### ADDENDUM #2 TO BID #19-047

BID NUMBER: 19-047

**PROCUREMENT FOR: Litchfield Exchange Roof Replacement**

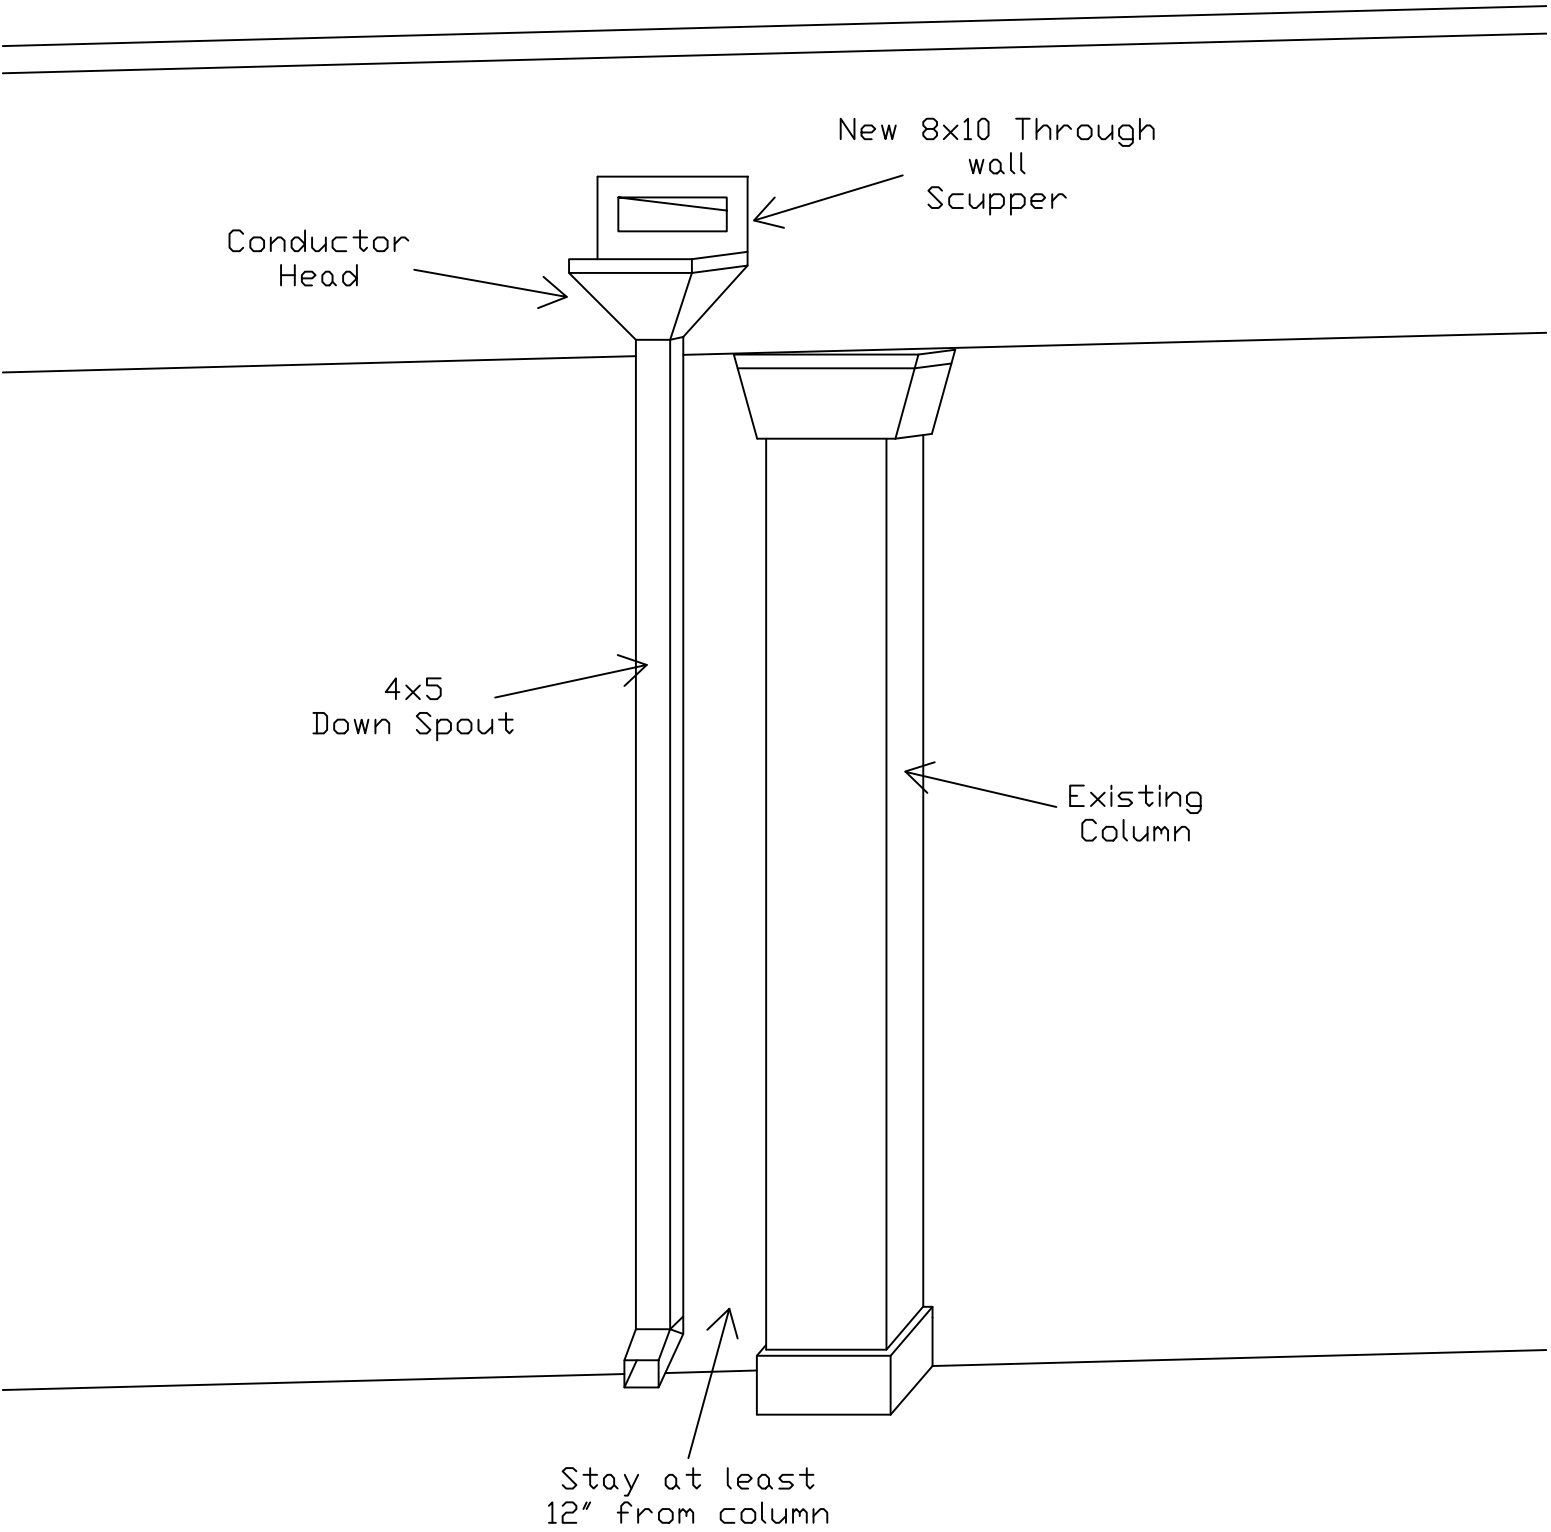
**Question 12:** So we are not providing new downspouts as the specs list?

**Response:** In the pre-bid meeting there was discussion about tying into the existing downspouts, however this has been changed to the following specifications:

“Contractor shall cut a square 8 x 10 inch hole through the complete wall. Contractor shall install an 8 x 10 through wall scupper and conductor head. Contractor shall install a new 4 x 5 inch downspout down the side of each column, one foot from the existing downspout, and terminate the new downspout(s) at ground level with a 4 x 5 inch elbow. See attached diagram.”
